Office Action Summary

10/771,289

DETAILED ACTION

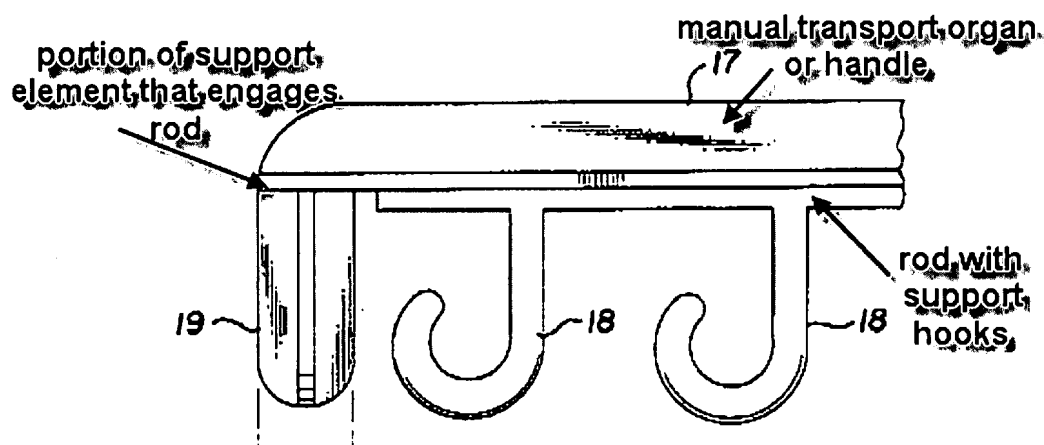
With regard to claims 8-13, 24, the support elements comprise a body or rod that carries a top section that may be used as a manual transport organ or handle to rotate the support elements or arms. The body or rod further comprises hooks 18 and is connected to the support element. See Belokin FIG2, as annotated by the Examiner, below.
